PACIFIC CREST ENVIRONMENTAL

February 25, 2013

KITSAP RIFLE AND REVOLVER CLUB 4900 SEABECK HIGHWAY NW BREMERTON, WASHINGTON 98312 PN # 105-016

RESPONSE TO KRRC SITE HAZARD ASSESSMENT

Figure 21. Colored surface map of V distribution in soils and other surficial materials of the conterminous United States.

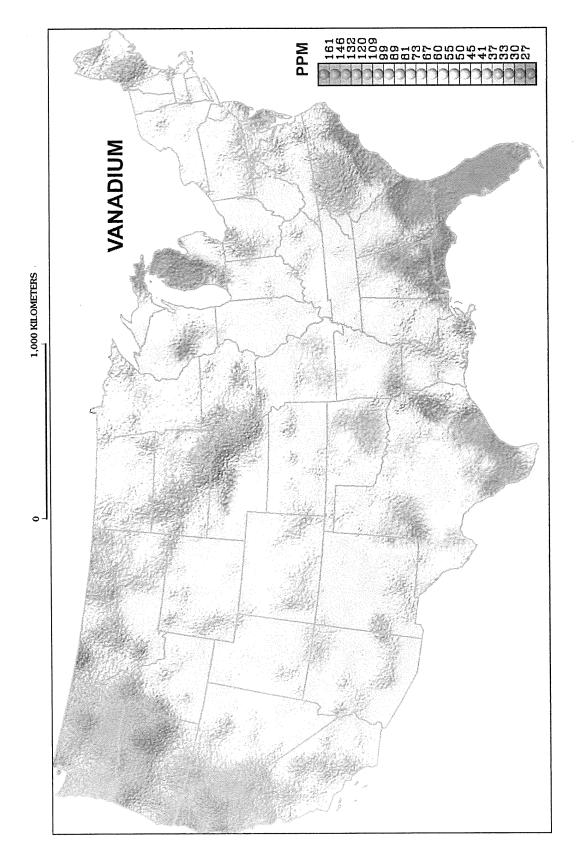
Further, a report forwarded to Pacific Crest by Charles San Juan at Ecology, which was prepared by the U.S. Geological Survey (USGS), titled *Geochemical Landscapes of the Conterminous United States – New Map Presentations for 22 Elements* (USGS 2001), presents delineated dispersion patterns for vanadium in soil. The USGS report found

general baseline concentrations of vanadium between approximately 89 and 161 mg/kg in Washington State (see attached Figure). Under the Model Toxics Control Act (MTCA), Ecology cannot require cleanup to below natural background concentrations. Therefore, the vanadium "exceedences," reported in Table 1 and Table 2 of the SHA, compared to the MTCA Method B soil cleanup level for direct contact (ingestion) route are not applicable to the KRRC. Accordingly, KRRC respectfully requests that the inaccuracies regarding vanadium in the SHA be corrected.

This section states that the source of vanadium is "unknown" (p. 3). However, published data in reference documents prepared by Ecology and USGS show that the concentrations of vanadium detected are naturally occurring and do not relate to KRRC's operations.
